To: Planning Committee
From: Jean Lamontagne
Director of Development
Date: August 21, 2006
File: RZ 06-341092
Re: **Application by All Line Construction Ltd. for Rezoning at 10551 Williams Road from Single-Family Housing District, Subdivision Area E (R1/E) to Single-Family Housing District (R1-0.6)**

RZ 06-341092

Staff Technical Comments

PLAN OF TREE SURVEY AND PROPOSED SUBDIVISION
OF LOT 27 BLOCK 19 OF SECTION 26 BLOCK 4 NORTH
RANGE 6 WEST NEW WESTMINSTER DISTRICT PLAN 18548

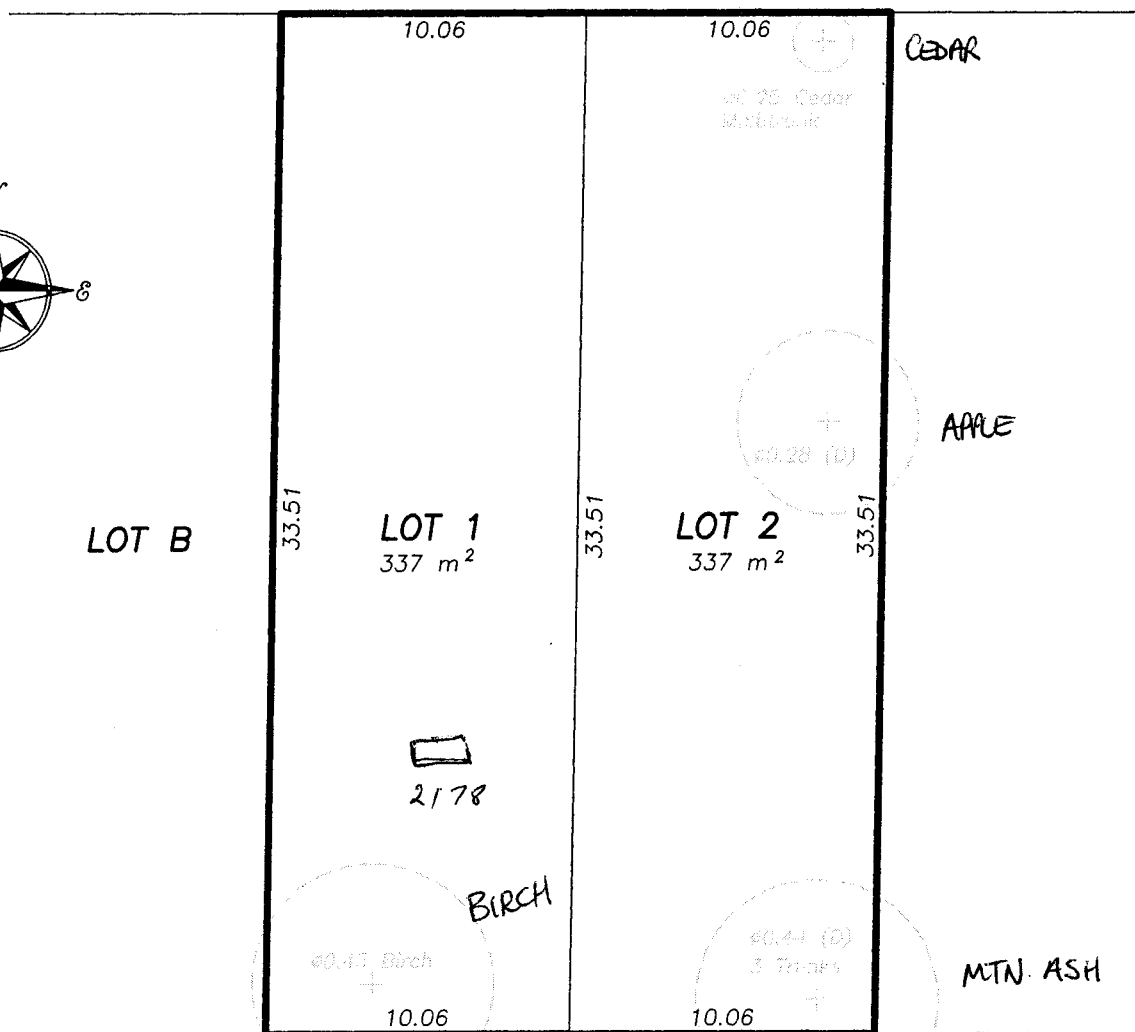
3) Common fruiting Apple, Diameter at base 315mm, H 6M, satisfactory. The location of this tree (see tree survey) is about 2M inside the east property line. The house plans described to me call for the new house to be built out to maximum allowable 1M set back. This will of course put the tree within the building envelope and it would therefore be (obviously) **not** suitable for retention.

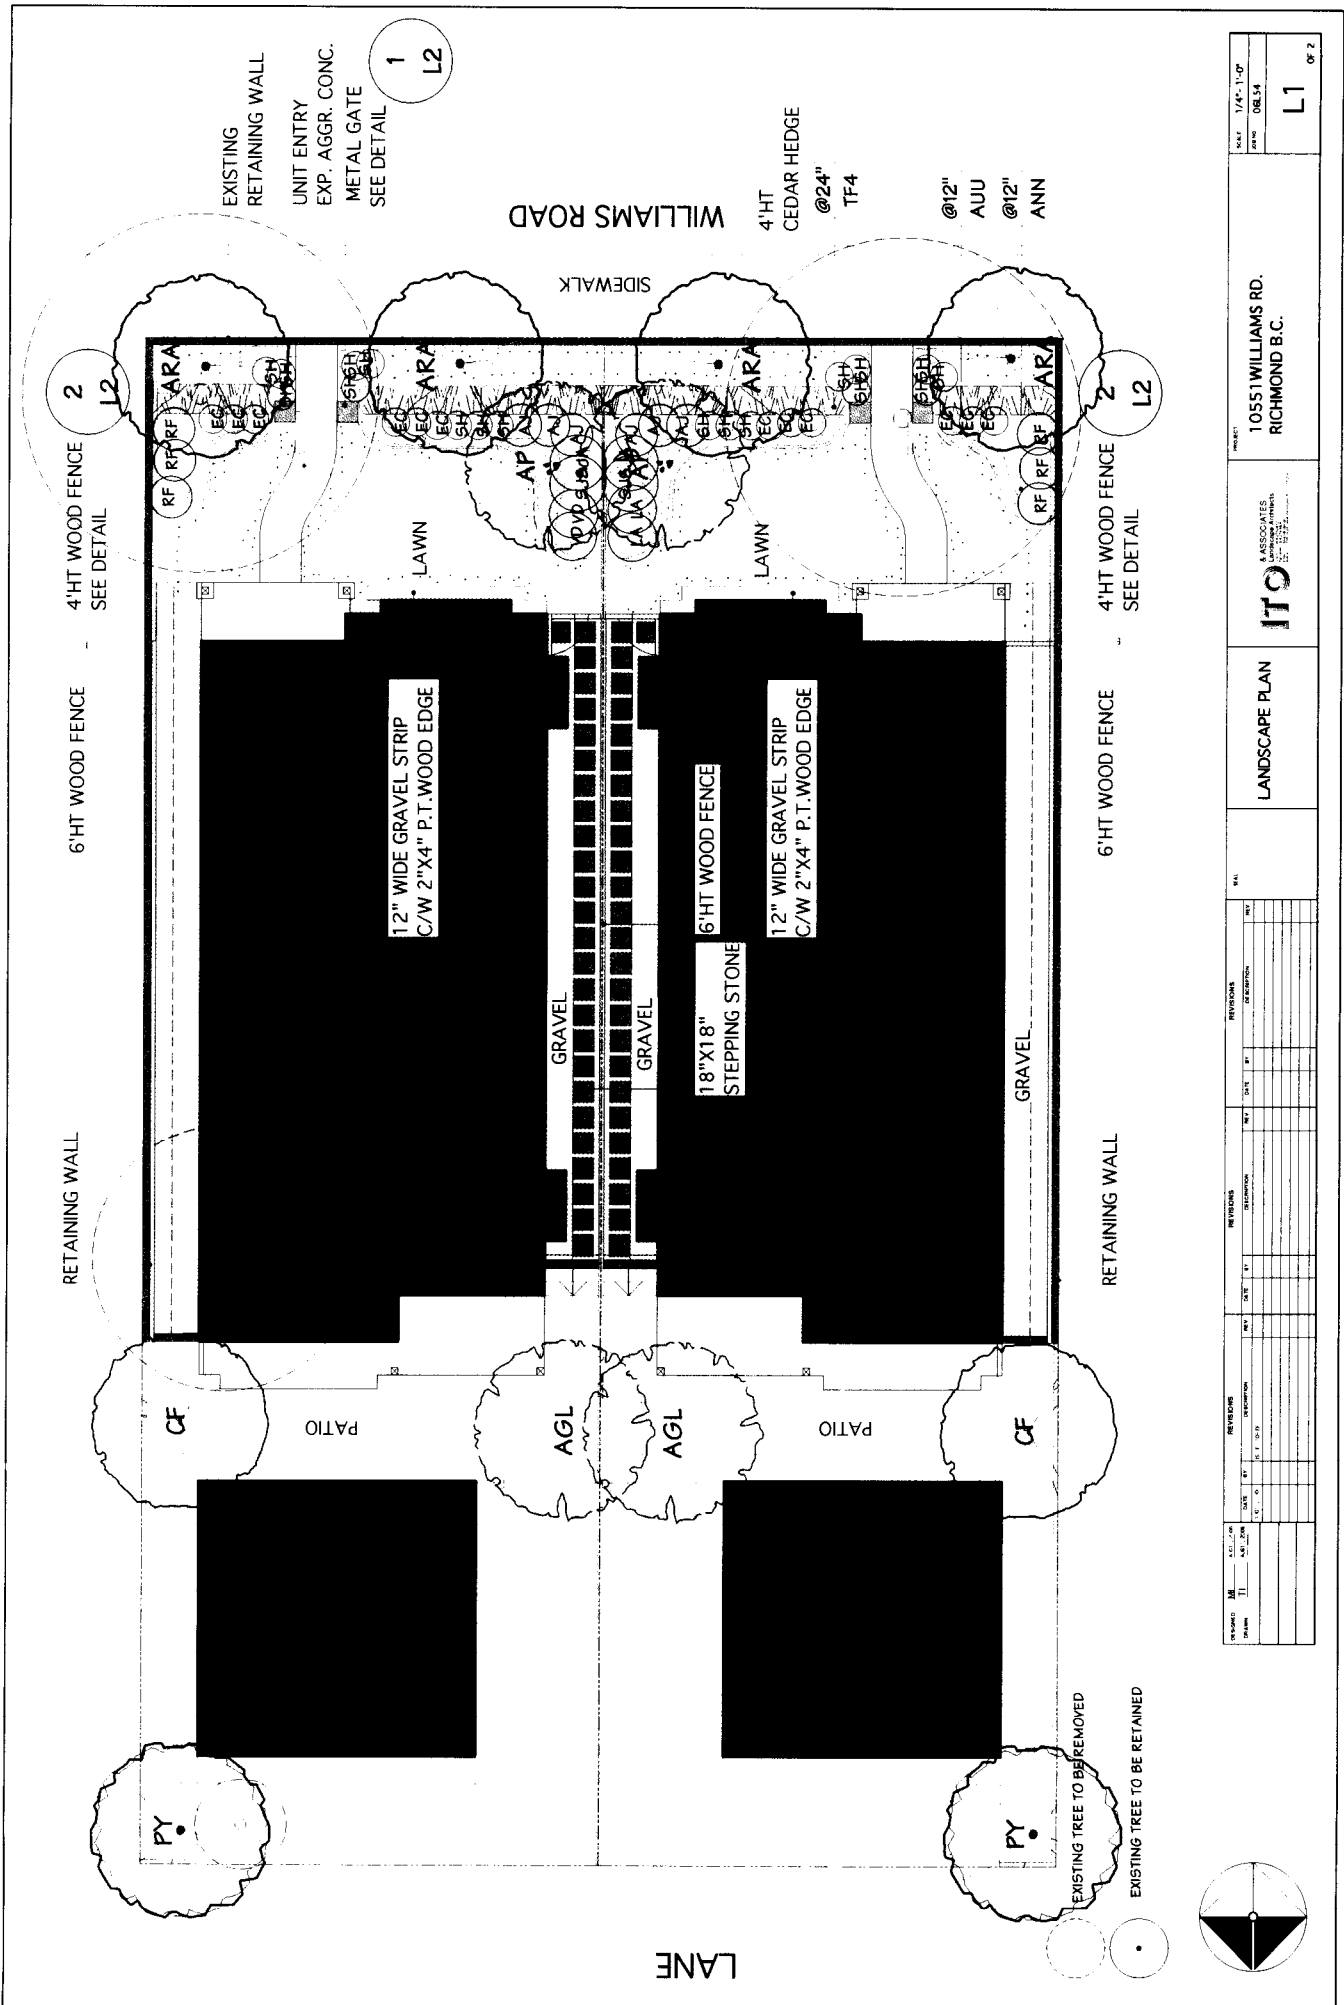
- The birch tree referred to in item 1) of the Arborist Report has been called satisfactory by the Arborist. This tree has excellent form and health and needs to be considered for retention. The recommendation for removal has been based upon the assumption that there shall be a .5 meter change in grade. This would definitely impact the tree if no mitigation measures are to be considered.

- Agree with the recommendation to remove the mountain ash tree described in item 2).
 - The apple tree described in item 3) is currently bearing nice juicy apples. Although not a specimen tree by any means (it requires pruning of select branches to create a balanced form) it is otherwise in good health. The recommendation for removal was based upon the assumption that the tree falls within proposed building envelopes only. If the plans are approved as such, then the tree would require removal.

- The cedar described in item 4) would be considered a large shrub not a specimen tree. I do not agree with the recommendation to move the shrub as the likelihood of it surviving transplant is not good. If it were to remain in situ, it should be preserved otherwise the shrub should be removed.
